Tennessee Valley Authority, 1101 Market Street, Chattanooga, TN 37402

CNL-16-190

Clinch River Nuclear Site
NRC Project No. 785

Subject: Submittal of Supplemental Information Related to Site Selection in Support of the Early Site Permit Application for Clinch River Nuclear Site

Figure 9.3-5. Redstone Arsenal Candidate Sites

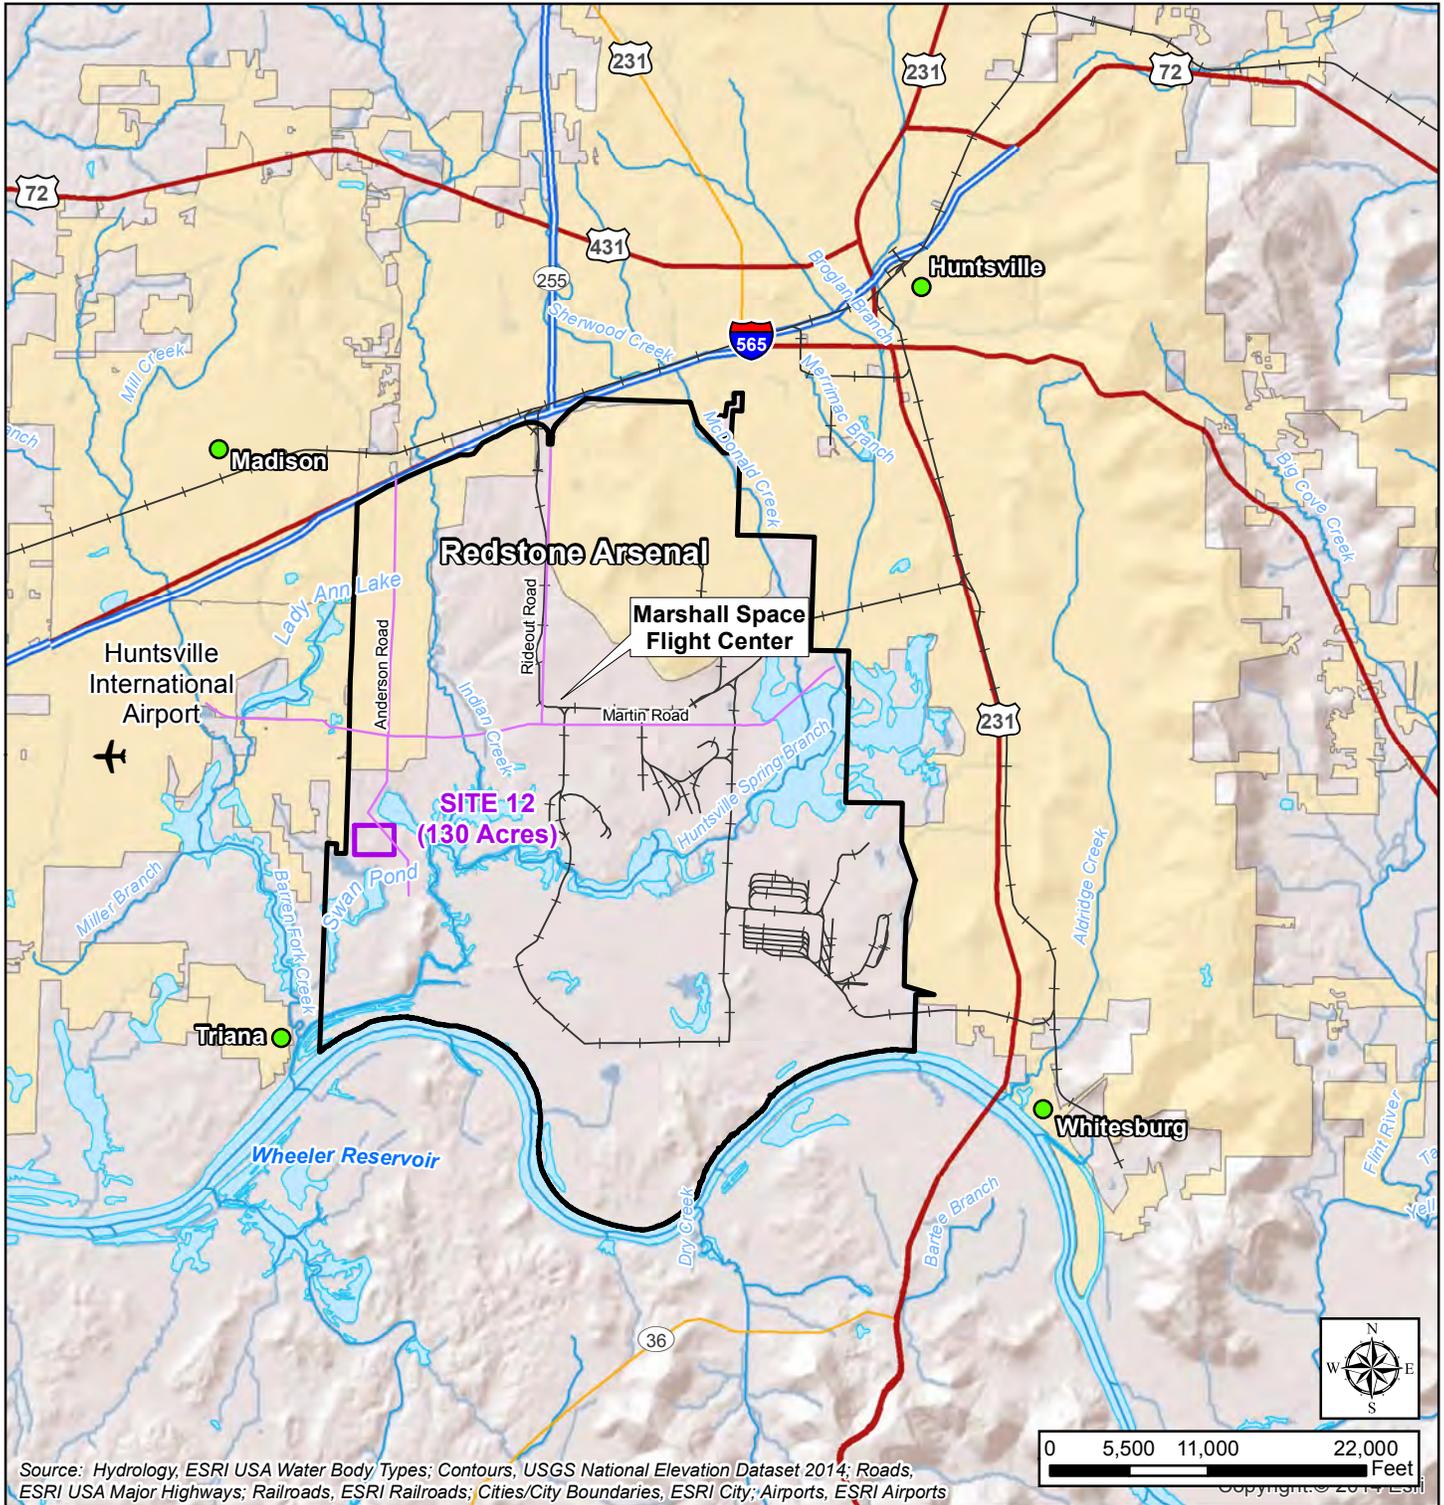
Information on workforce access to the CRN Site is in ER Subsection 2.5.2.2.1, "Roads." Information on workforce access to ORR Sites 2 and 8 and Redstone Arsenal Site 12 is being added to ER Subsection 9.3.4.1.5. Figures 9.3-5, 6, 7, and 8 are being updated to show the proposed access roads and road names.
